RE: 150 Steeles Avenue East and 248, 250 & 314 Martin Street, Milton, Proposed Mixed-Use Development

This memorandum is intended to provide additional information to address the Town’s transportation-related comments dated April 2, 2026 and April 8, 2026, and the Region’s transportation comments dated April 17, 2026, in regard to BA Group’s February 2026 Transportation Considerations Report (“the February 2026 BA Group Report”). We trust that the enclosed memorandum provides the appropriate information requested by the Town. Please feel free to let us know if you have any questions or require any additional information.

1.0 BA GROUP RESPONSES TO TOWN COMMENTS

150 STEELES
 VEHICLE MANOEUVRING DIAGRAM
 BLOCK 4
 HALTON REGION GARBAGE TRUCK (LEFT TURNS)

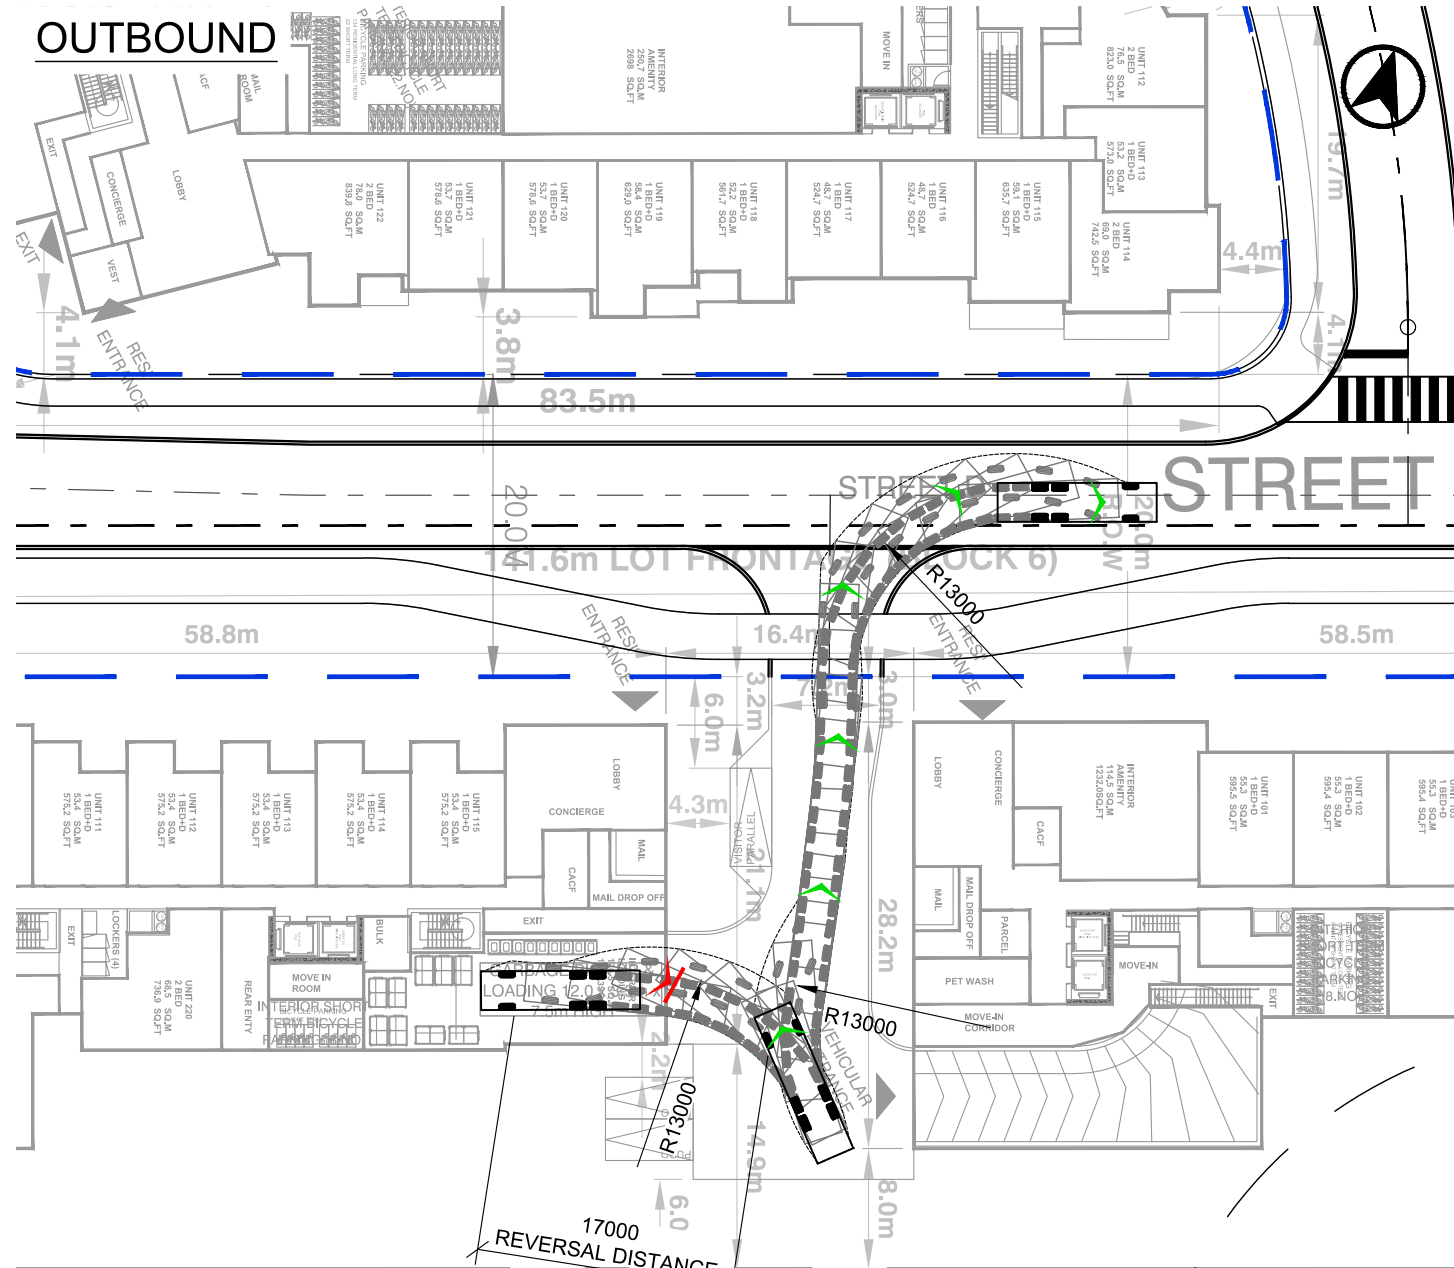
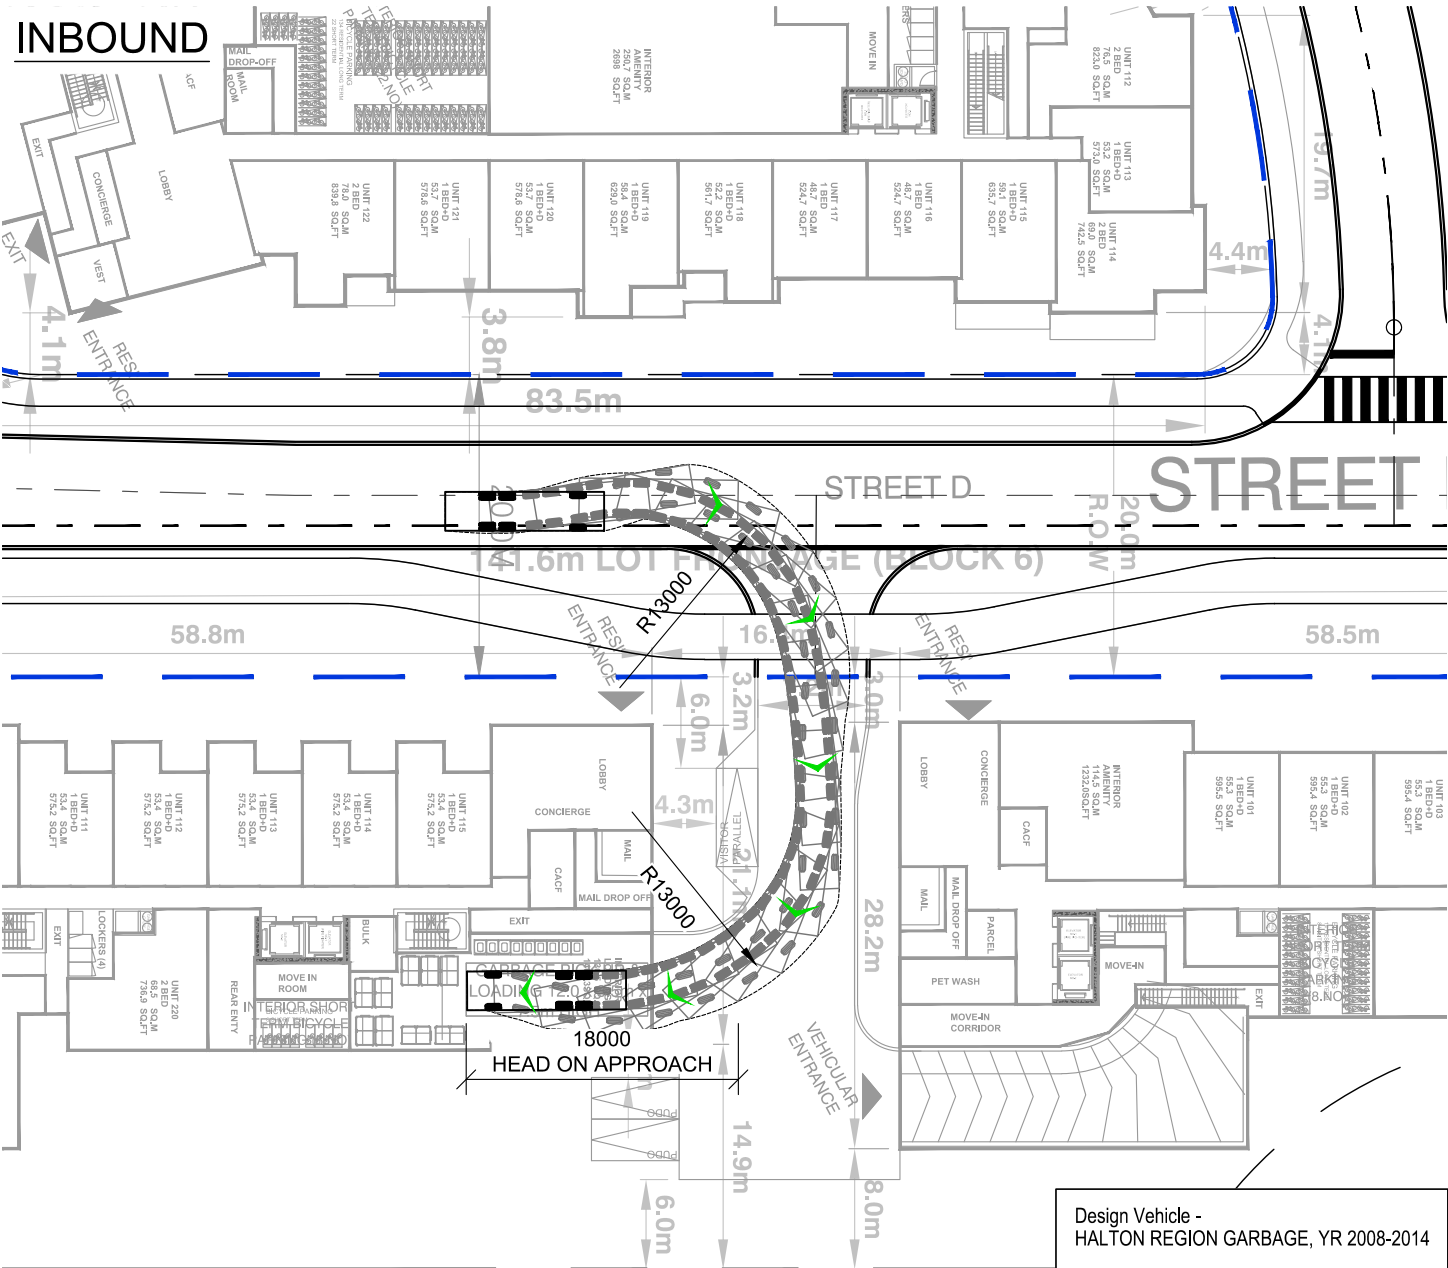
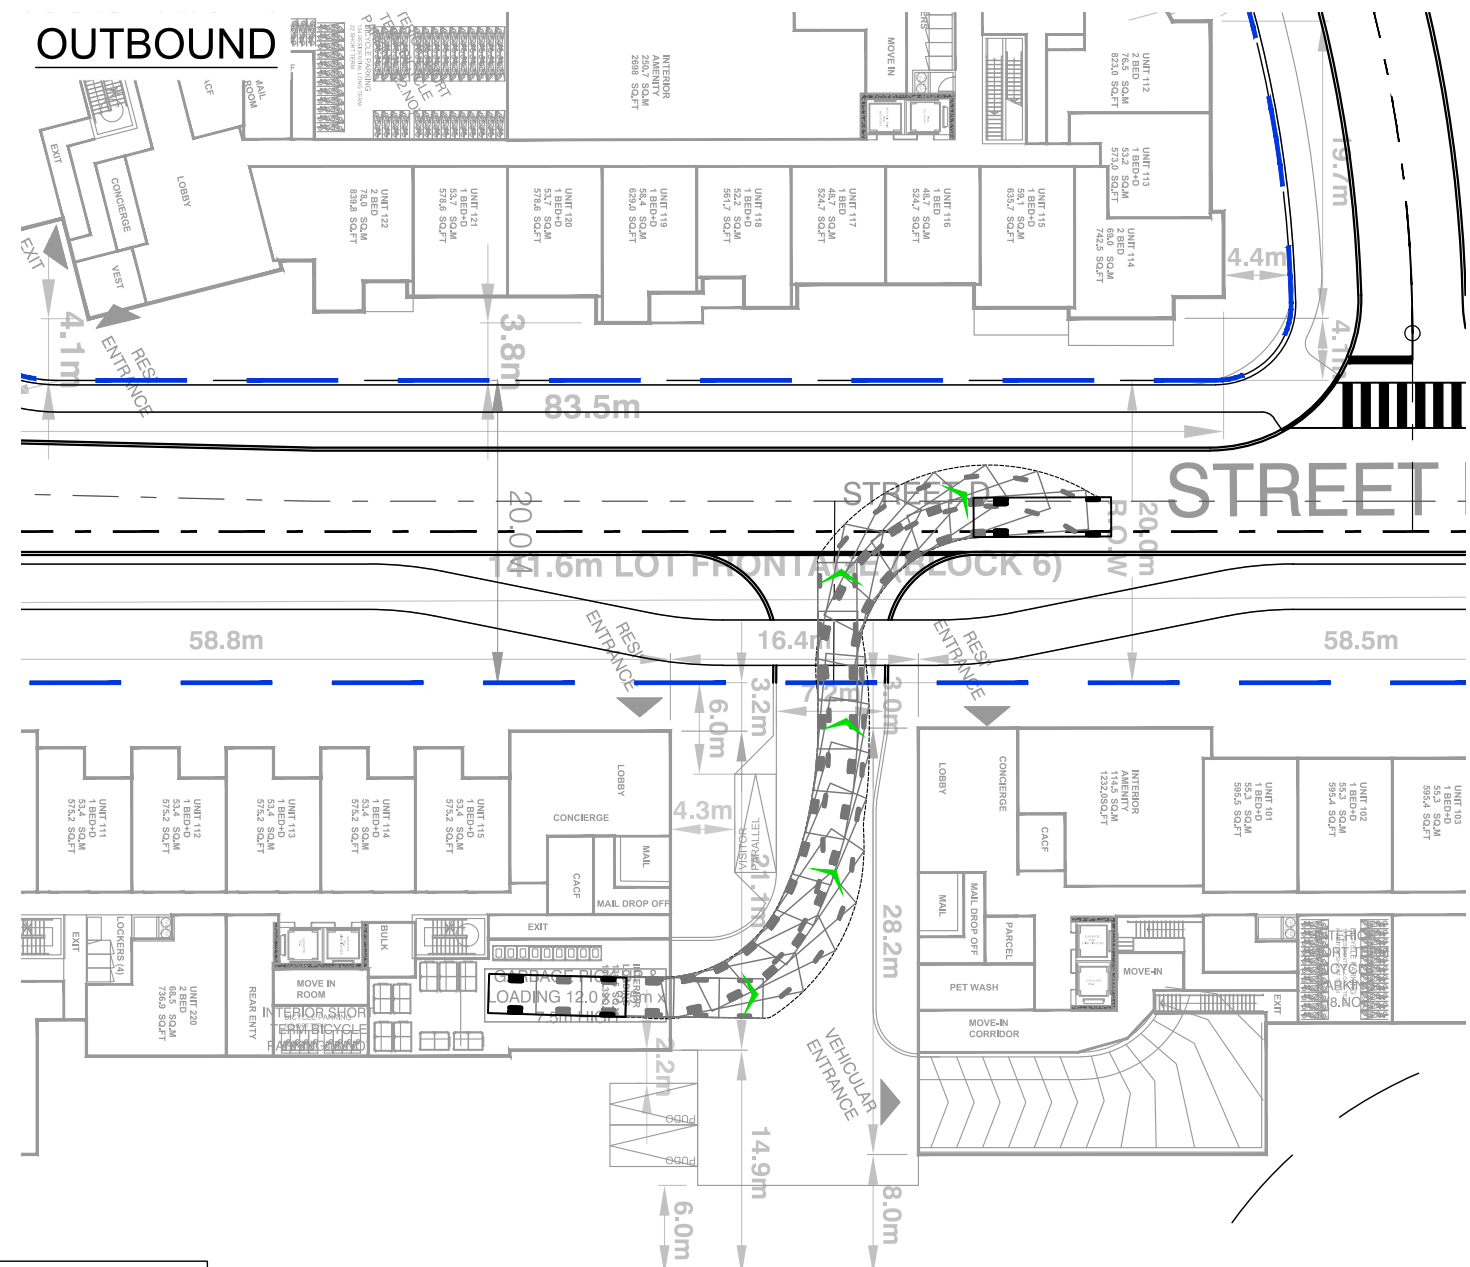
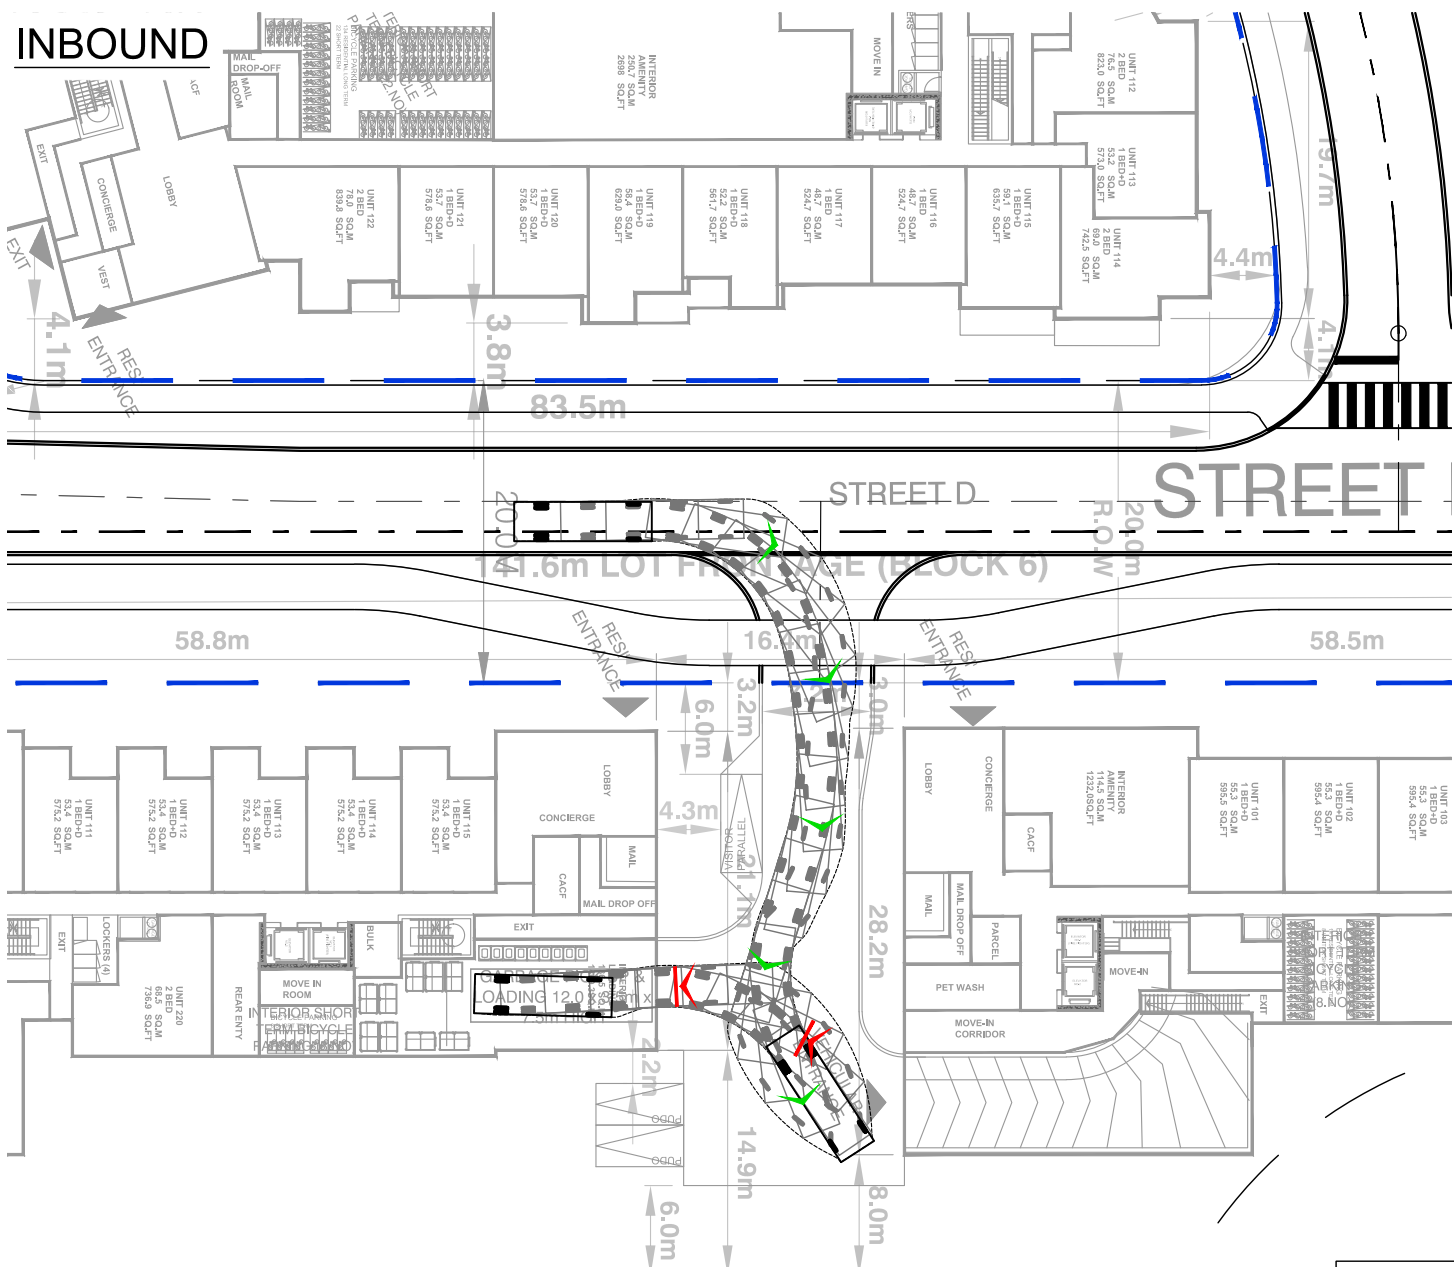
Comment: Please indicate the centreline turning radius in all locations where the waste collection vehicle is turning and approaching loading area (minimum 13 metres).

Comment: Please indicate the length of the head-on approach (minimum 18 metres).

Comment: Please indicate the distance the waste collection vehicle will be required to reverse (maximum 18 metres).

Comment: Please indicate the waste collection vehicle route from the municipal road to the Collection Point and back to the municipal road. Please ensure to include the turning radius of all turns.

Comment: Where continuous forward movement of waste truck cannot be achieved, a cul-de-sac or T-turnaround may be permitted if 13m turning radius and max 18 metre backup distances can be met.

Comment: Notwithstanding the loading requirements set out in the Town 's Zoning By-law, the loading spaces in Phase 1 of the development are proposed to be 12 m x 3.5 m (overhead waste collection) in size.

- All dimensions on the below loading areas including centre line turning radii.
- One truck maneuvering diagram. The overlay provided below makes it difficult to determine the path of the collection vehicle.

Response: The centreline turning radius of a minimum of 13 metres is illustrated on the Vehicle Manoeuvring Diagrams (VMDs) attached in **Appendix C**.

Response: The 18 metres head-on approach is illustrated on the VMDs attached in **Appendix C**.

Response: The reversal distance of the waste collection vehicle is illustrated on the VMDs attached in **Appendix C** and illustrate reversal distances of 18 metres or less.

Response: VMDs provided in **Appendix C** illustrate waste collection vehicles entering each block from the municipal road and leaving each block onto the municipal road.

Response: VMDs provided in **Appendix C** illustrate waste collection vehicles entering and existing each site in a forward motion. The turning radius (minimum 13 metres) and the reversal distances (maximum 18 metres) are illustrated on the VMDs.

Response: Vehicle Manoeuvring Diagrams provided in **Appendix C** illustrate the waste collection vehicle entering and exiting the proposed waste collection areas with dimensions (minimum 13 metres turning radius, minimum 18 metres head-on approach and maximum 18 metres reversal distance).
